SITE SUPPLEMENTAL INSTRUCTION

PROJECT: Forestside Estates
Attmar & Palleschi Drive
Brampton, ON

SITE SI NO. M-7

PURPOSE: To revise make-up air risers to suit space requirements & City Permits comments.

DRAWN	CHECKED	SCALE
MC	LM	1:150
DATE	PROJECT	DRAWING
MAY, 2019	18-017	M-4
		OF

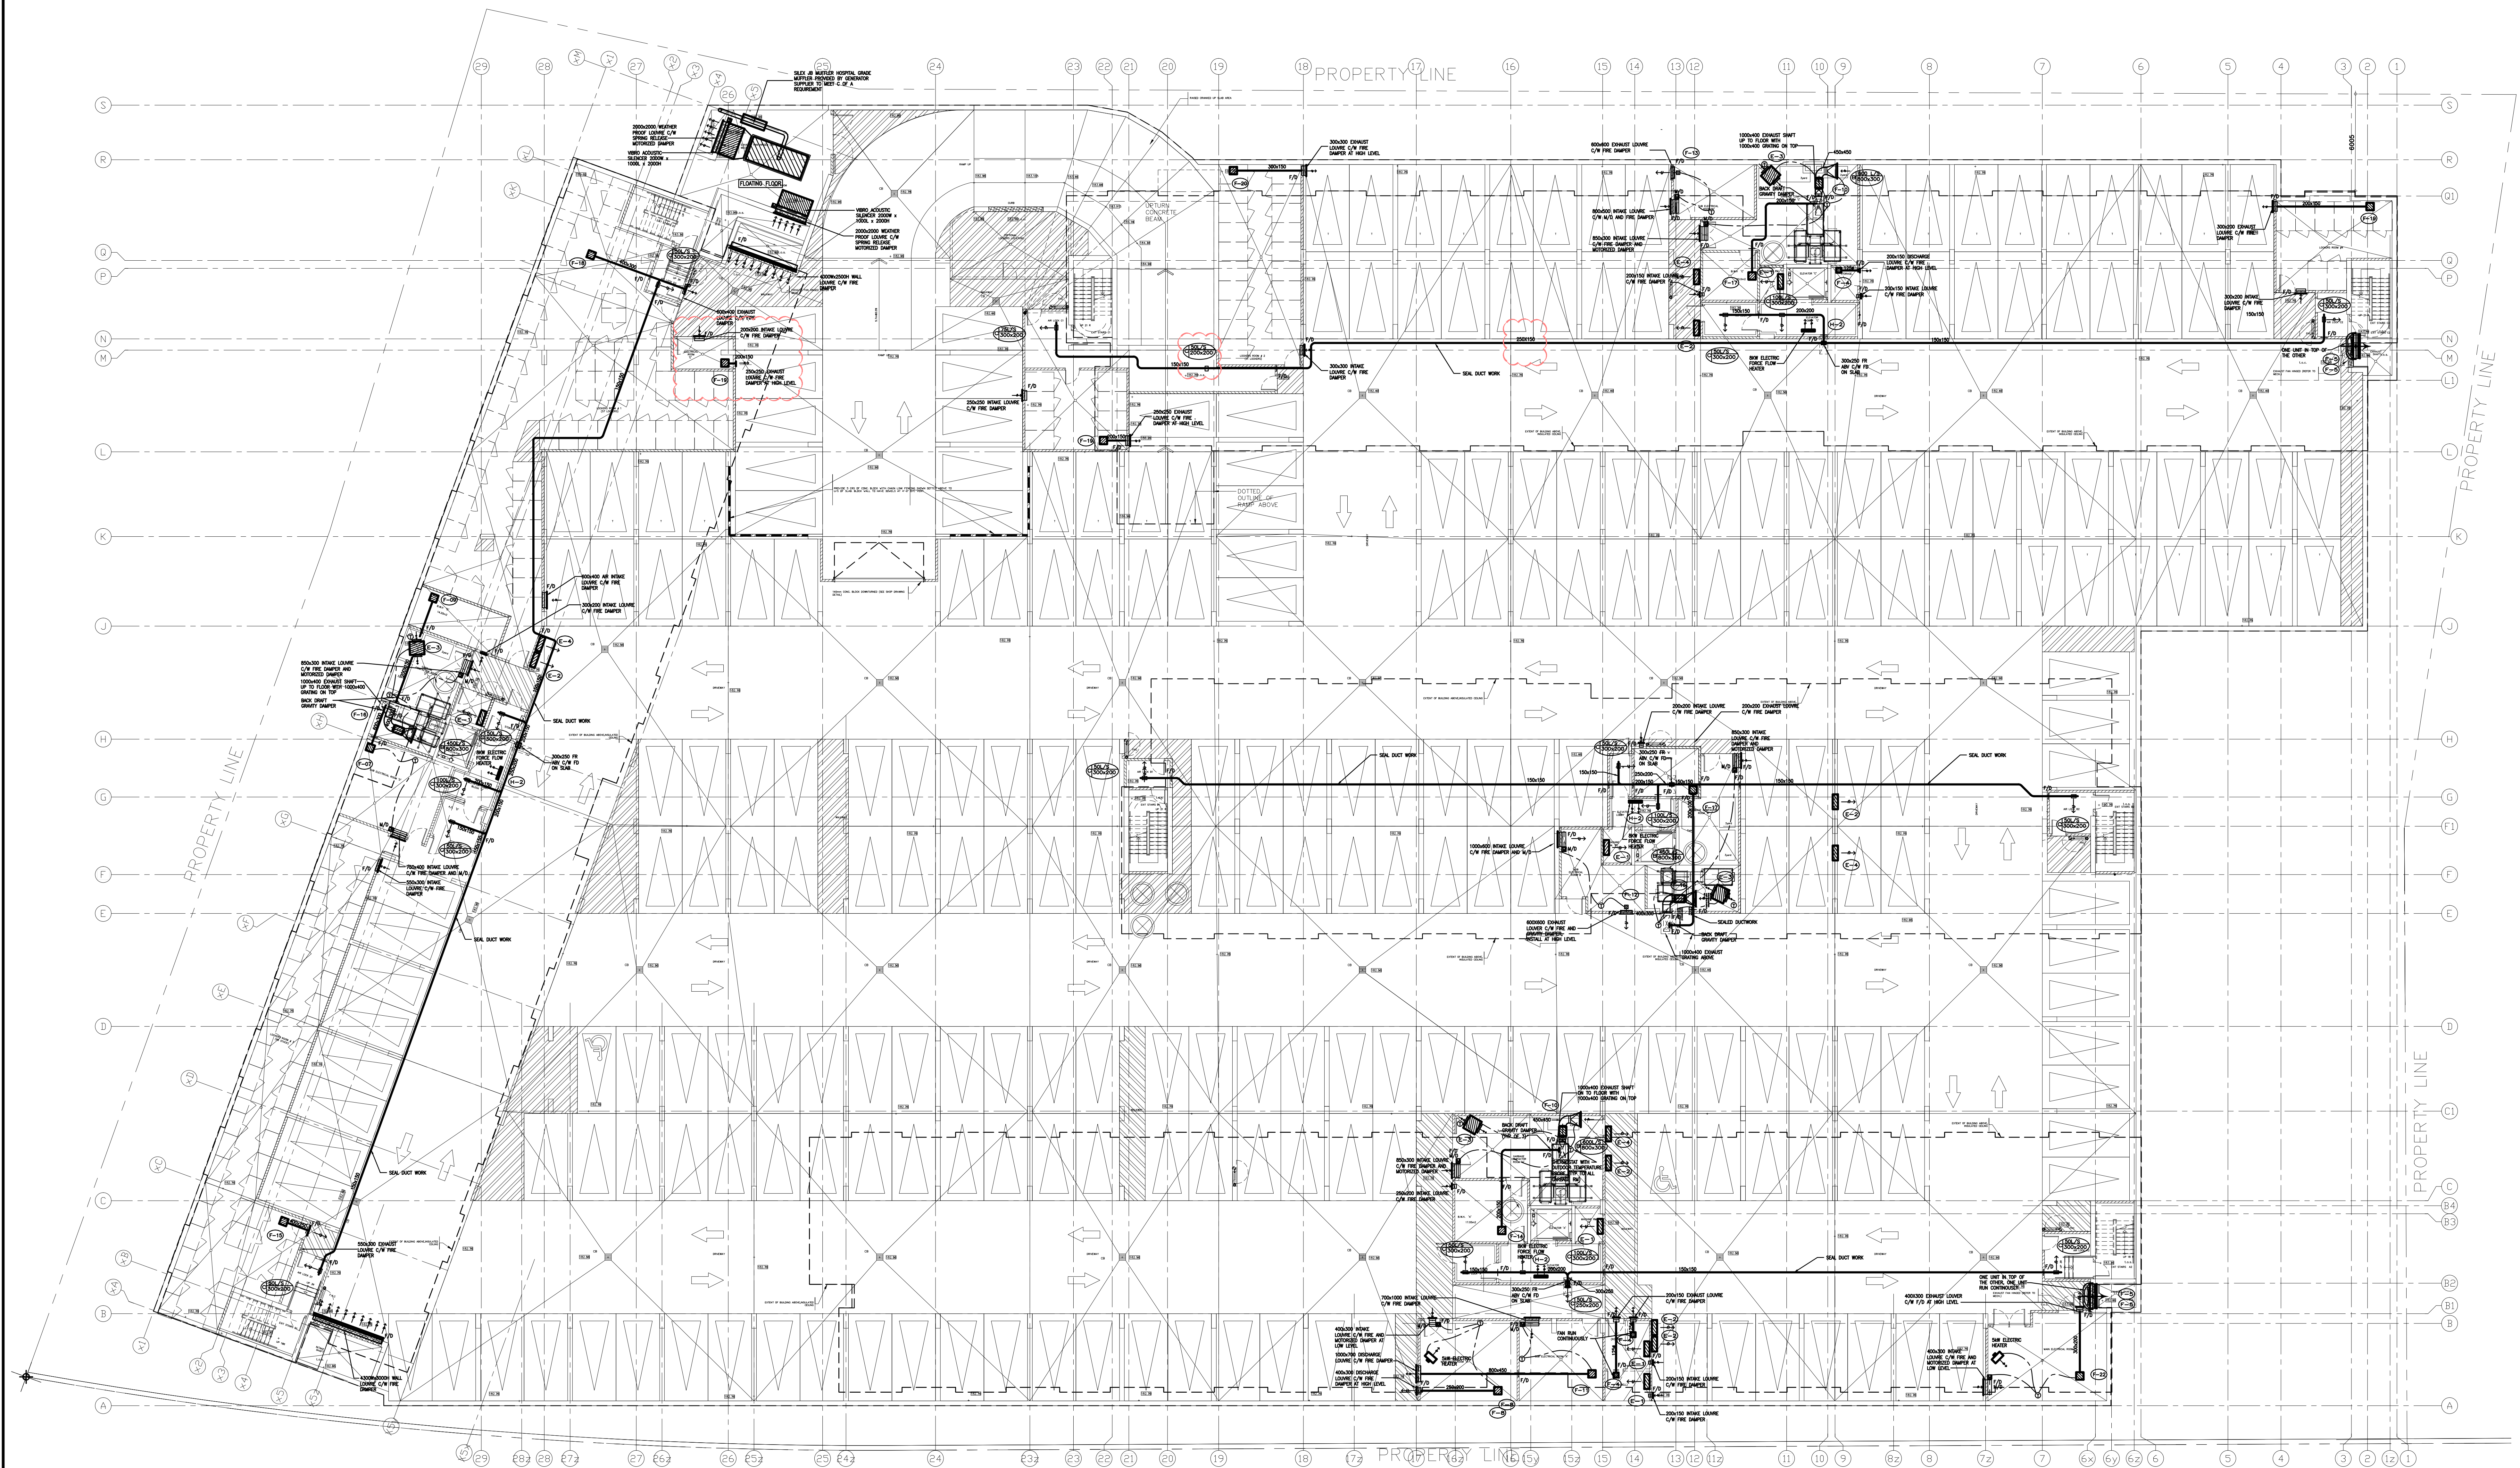
- 1.1 Add: Supply air grille in air lock grid line 19 & M and riser duct size.
- 1.2 Add: Exhaust fan F-19 c/w exhaust duct & grille and intake air louvre grid line 2G & N.

DRAWN MC	CHECKED LM	SCALE 1:50
DATE MAY, 2019	PROJECT 18-017	DRAWING M-5A OF -

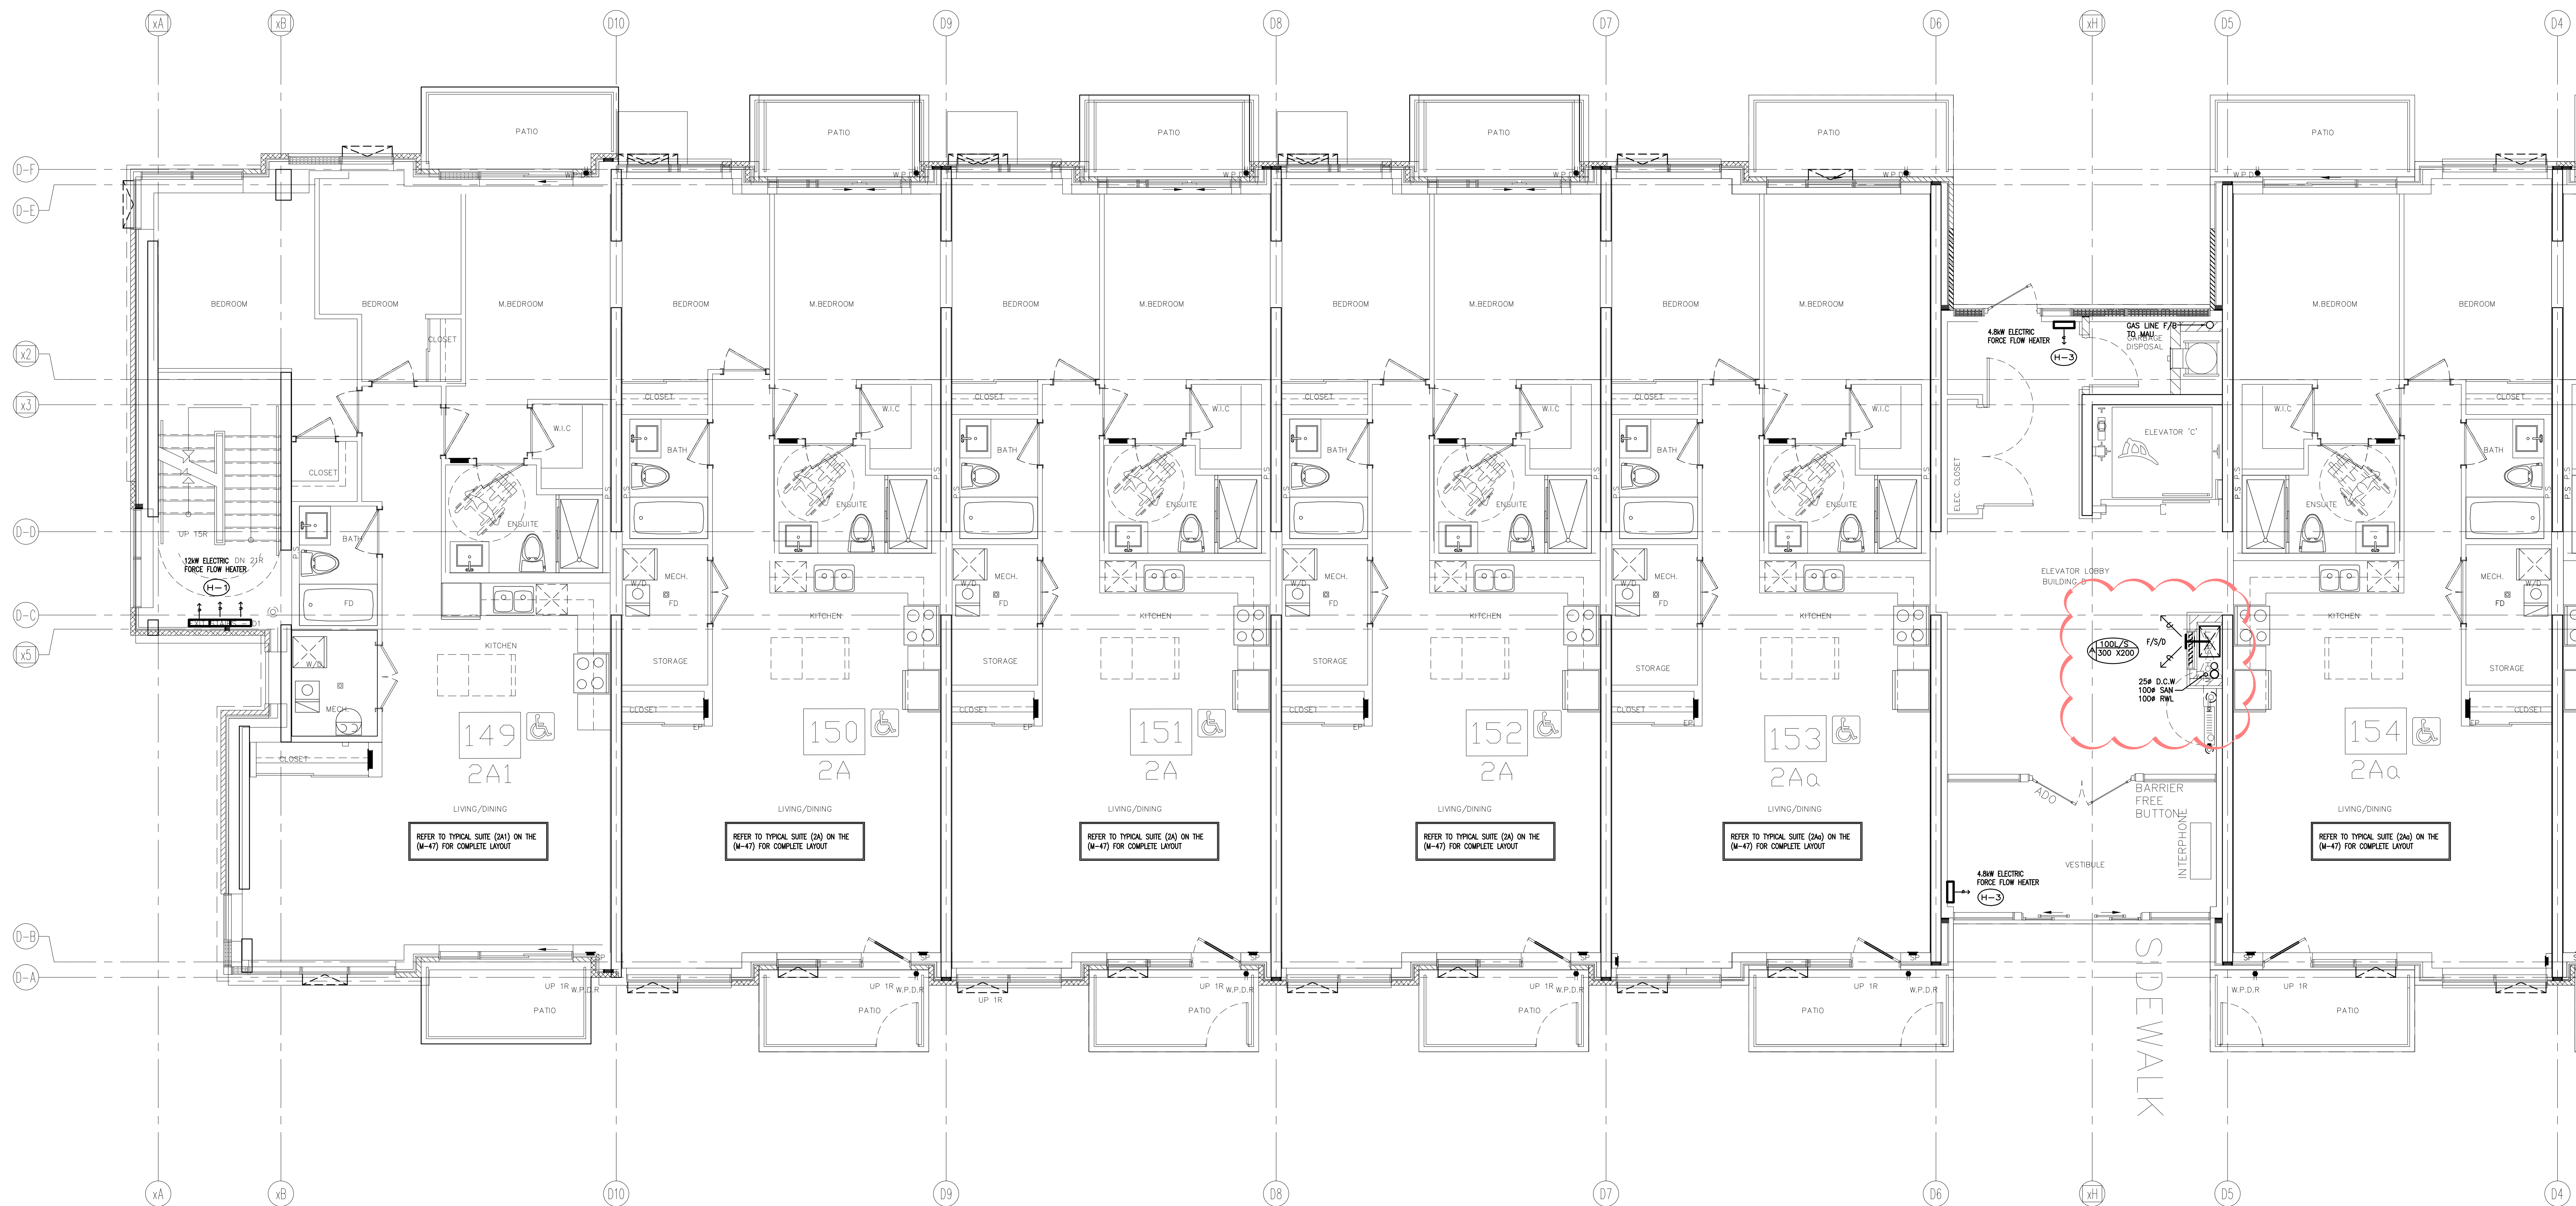
- 2.1 Clarify: Make-up air riser.

TITLE BLOCK 'D' 2ND FLOOR - HVAC 1		
PROJECT BRAMPTON STACKED FORESTSIDE ESTATES		
ATTMAR + PALLESCHI DRIVE BRAMPTON, ONTARIO		
DRAWN MC	CHECKED LM	SCALE 1:50
DATE MAY, 2019	PROJECT 18-017	DRAWING M-7A OF -

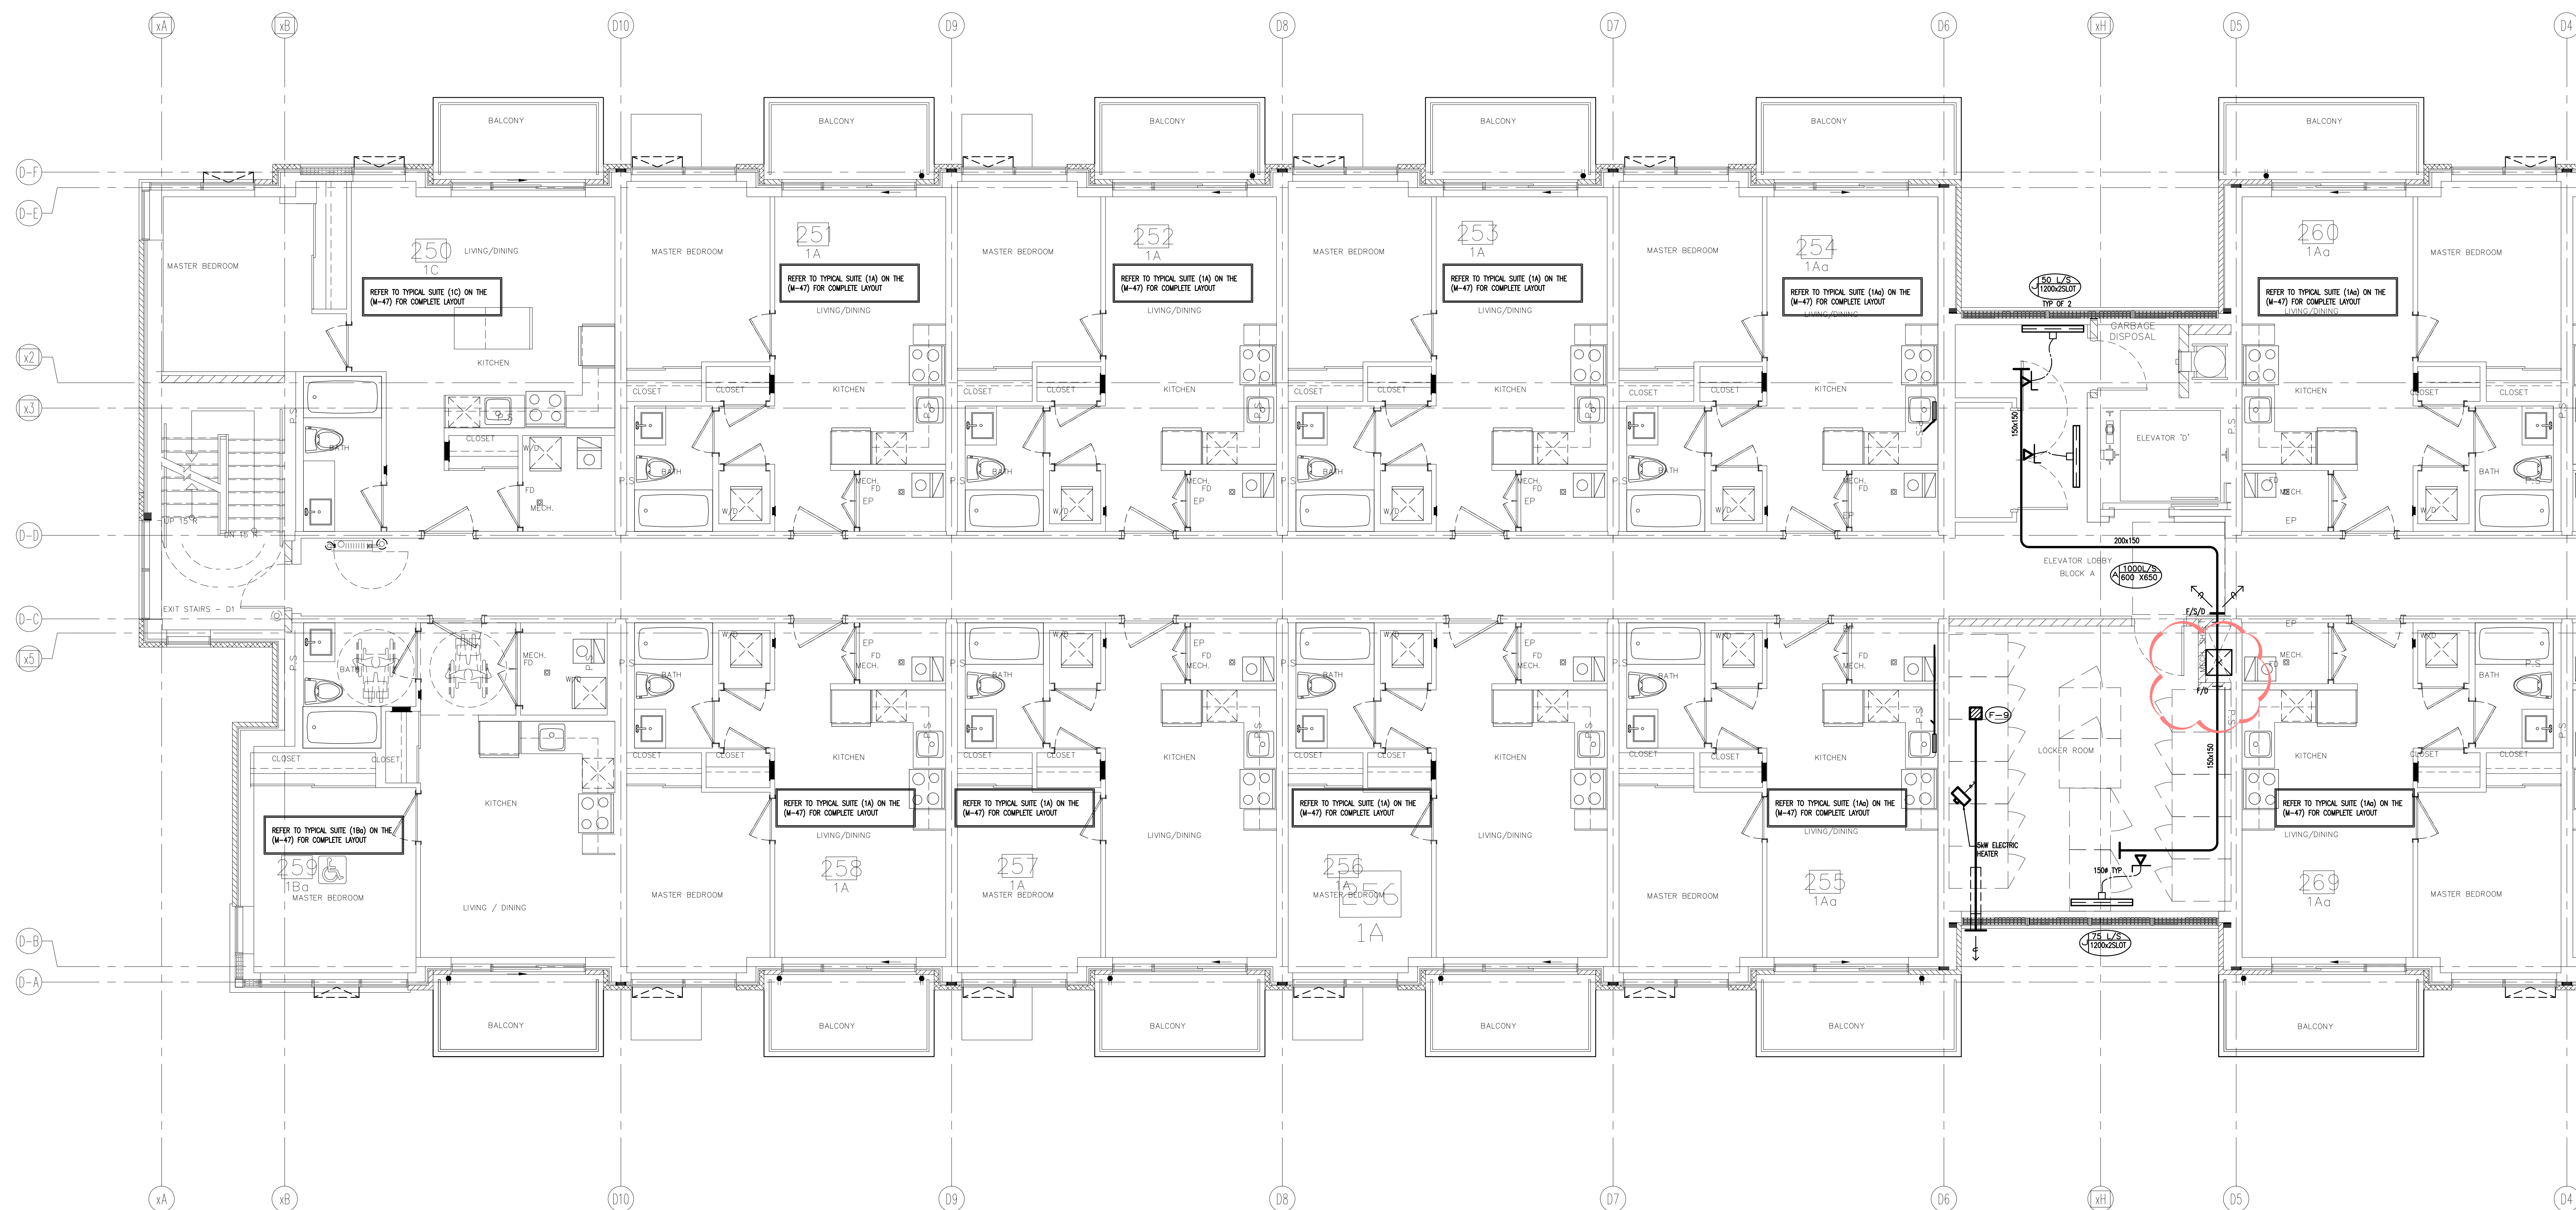
- 3.1 Relocate: Make-up air riser.
Locate make-up air riser 600mm.
Back from face of corridor wall.
